LOT 1A, FALCON MARKETPLACE

7520 FALCON MARKET PLACE EL PASO COUNTY, COLORADO DEVELOPMENT PLAN

V1_Site Development Plan Comments.pdf Markup Summary

COVER SHEET

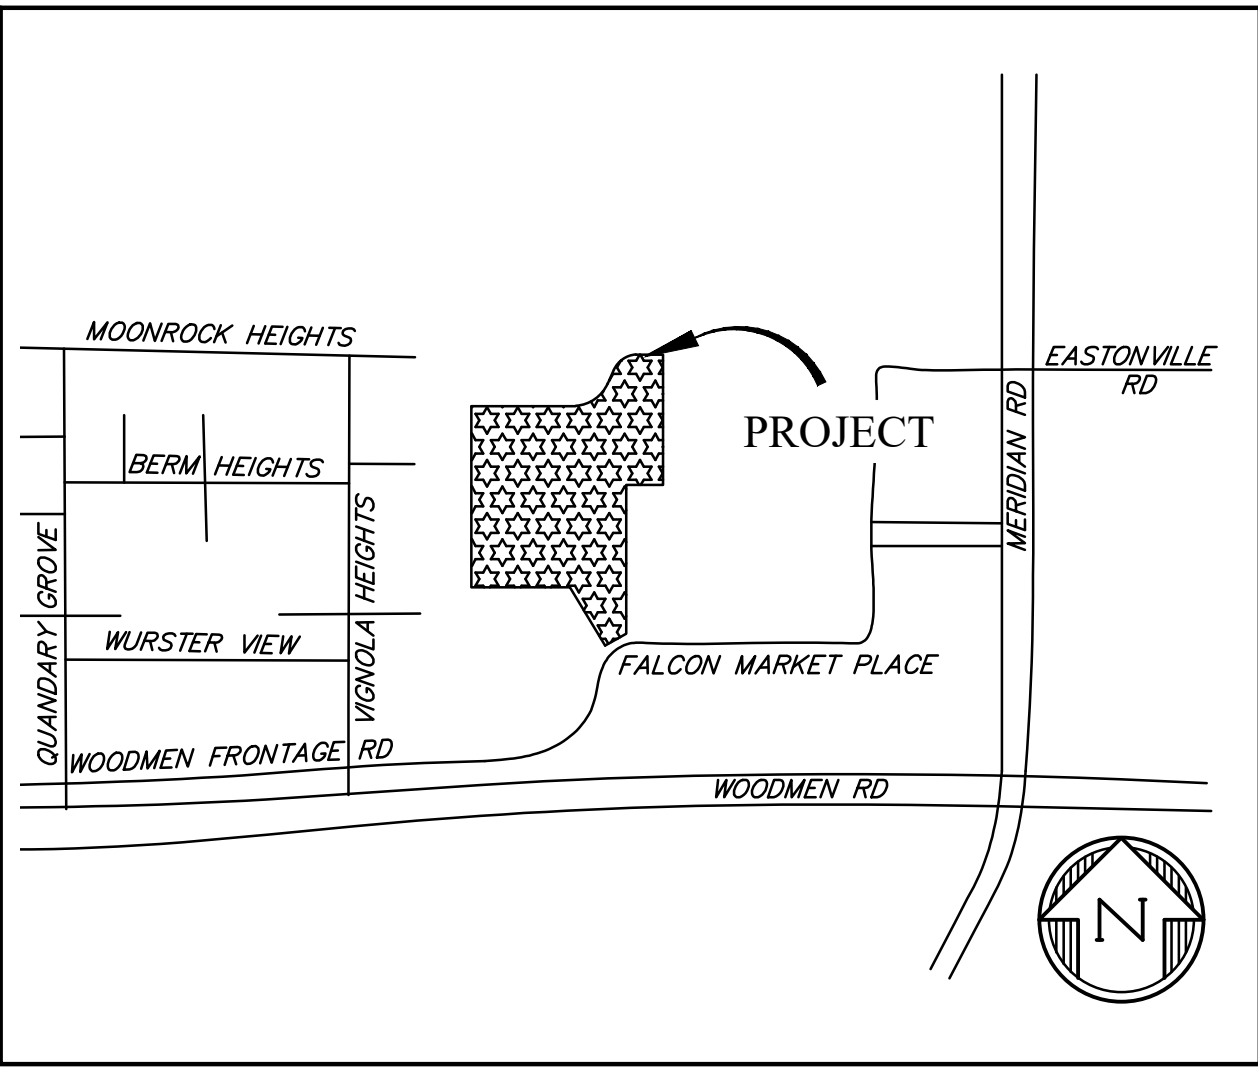
Add Signature Block for El Paso County Planning & Community Development Director (minimum 1 inch x 2 inches)

UTILITY
&
SITE PLAN

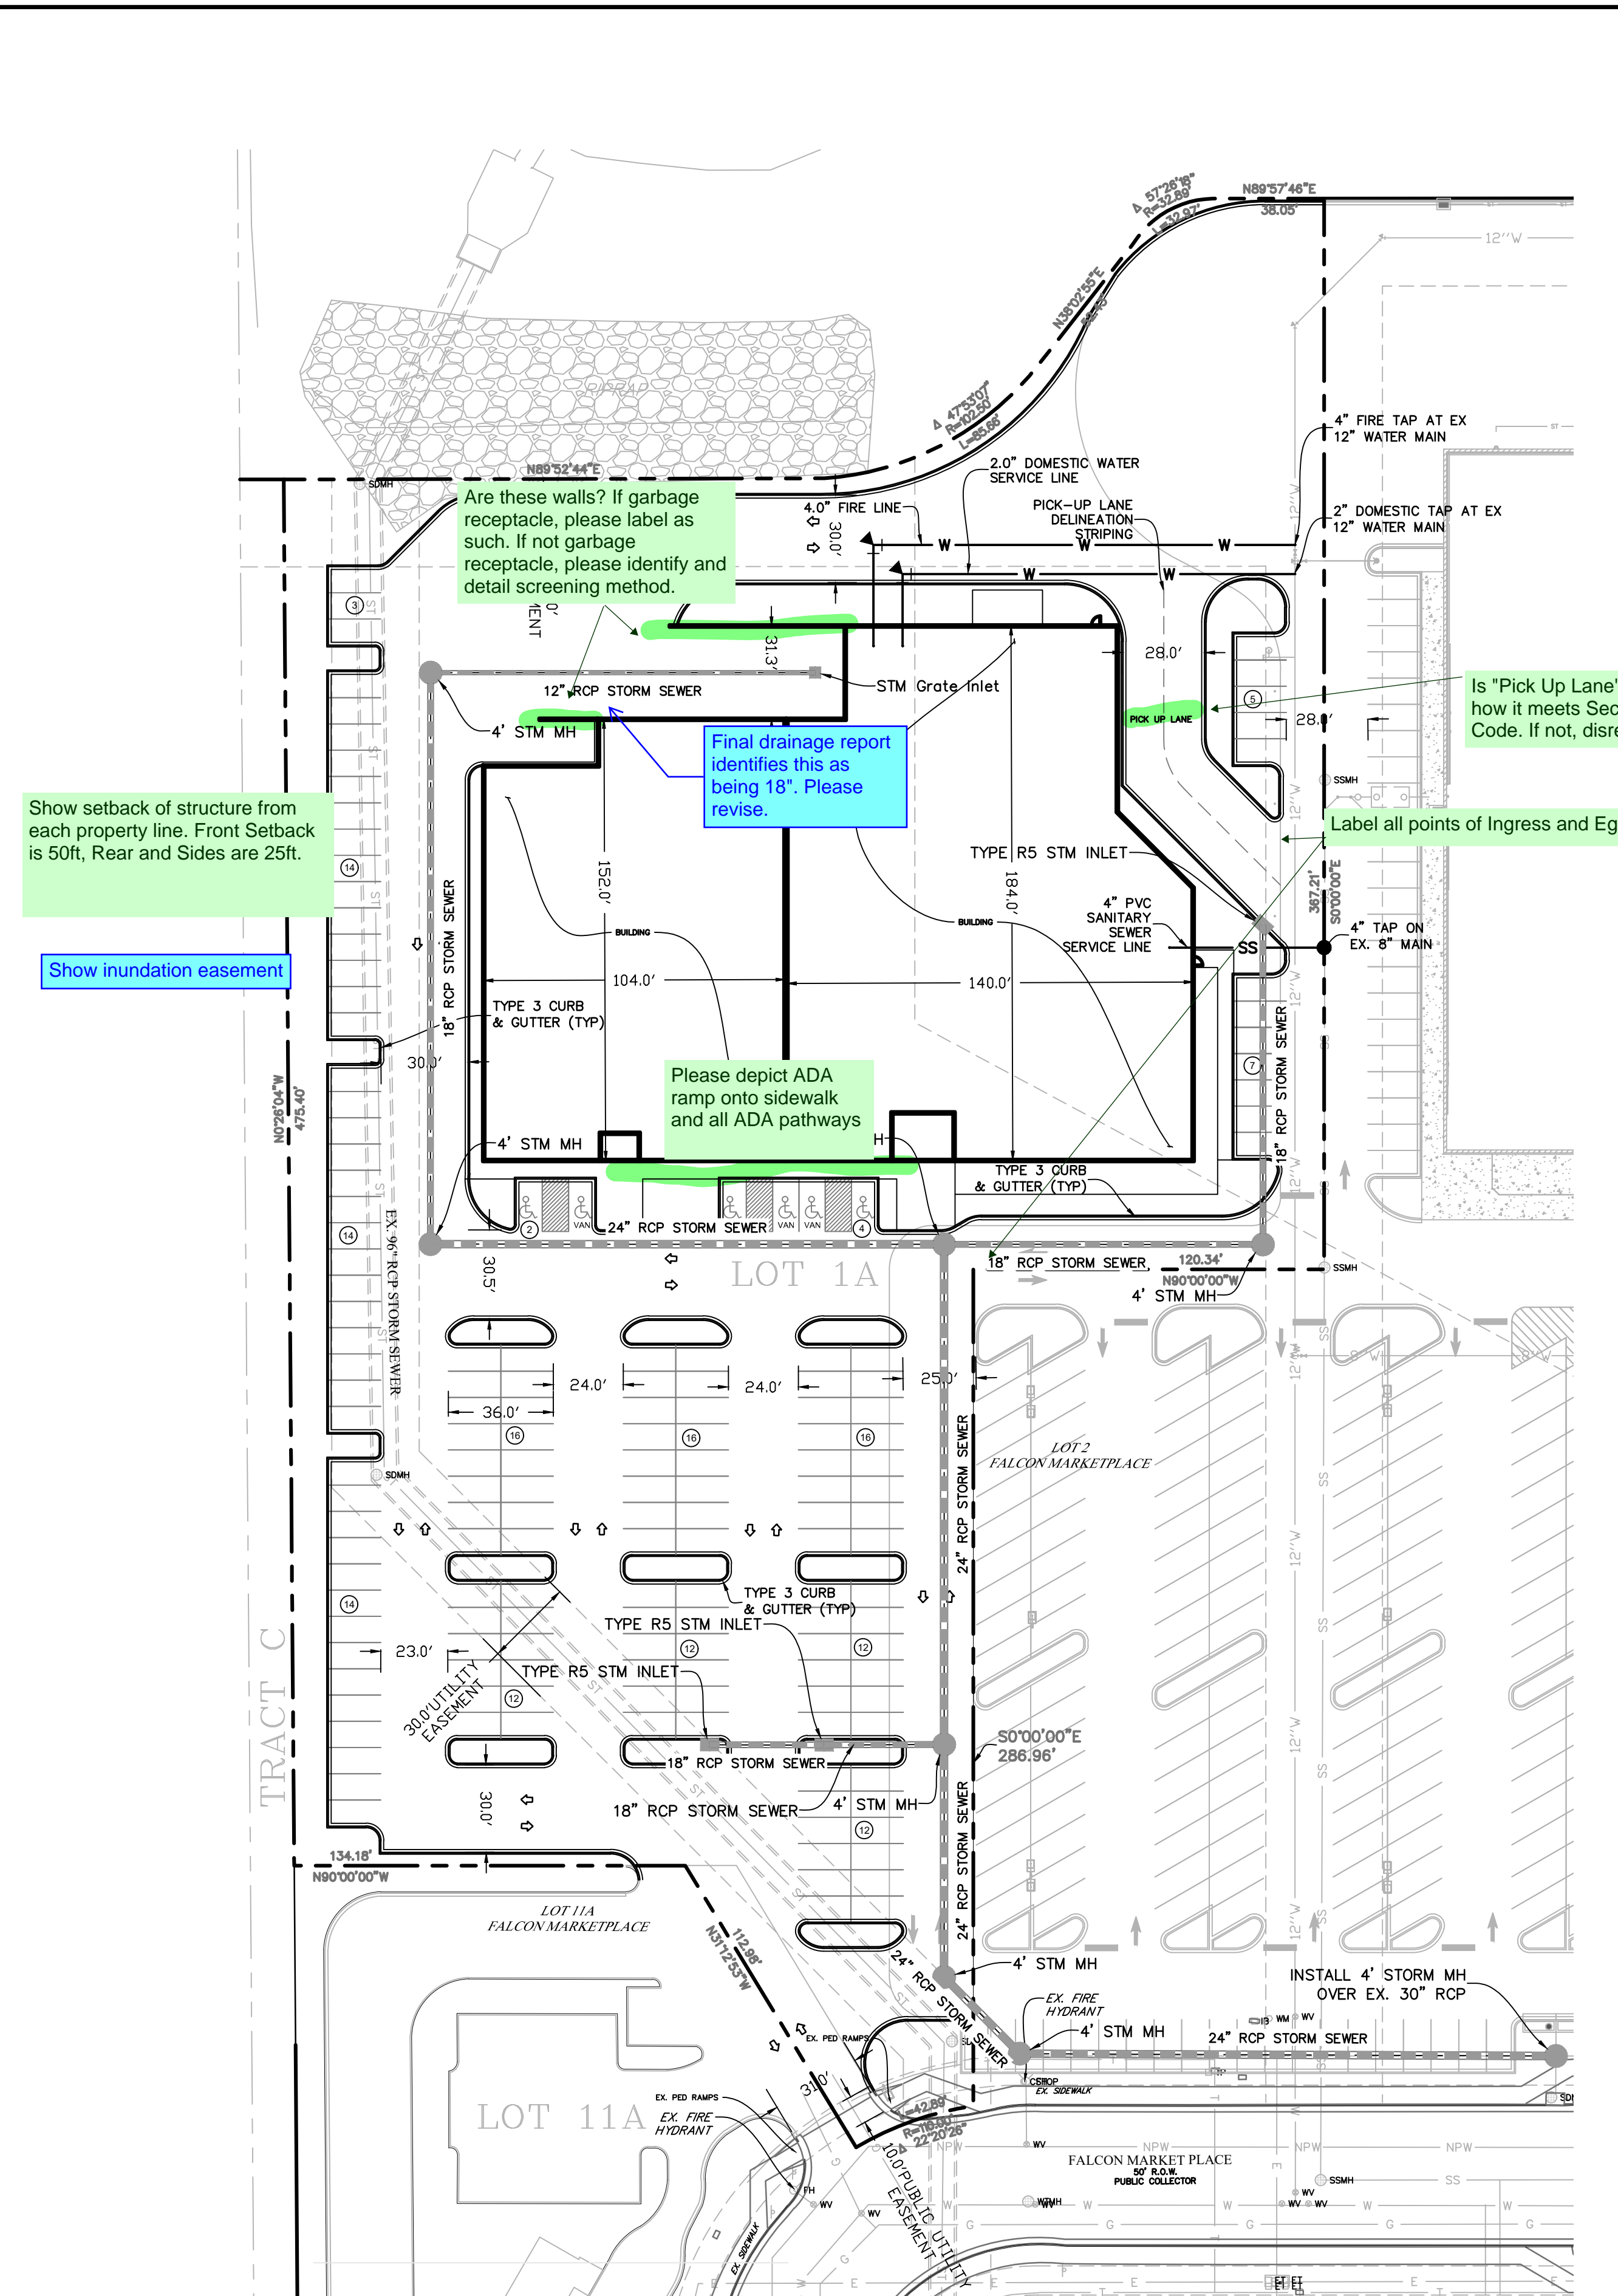
Show setback of structure from each property line. Front Setback is 50ft, Rear and Sides are 25ft.

Show inundation easement

Are these walls? If garbage receptacle, please label as such. If not garbage receptacle, please identify and detail screening method.

Final drainage report identifies this as being 18". Please revise.

Please depict ADA ramp onto sidewalk and all ADA pathways

Is "Pick Up Lane" a drive-thru? If so, please show how it meets Section 6.2.5.G.1 of the Land Dev. Code. If not, disregard comment.

Label all points of Ingress and Egress
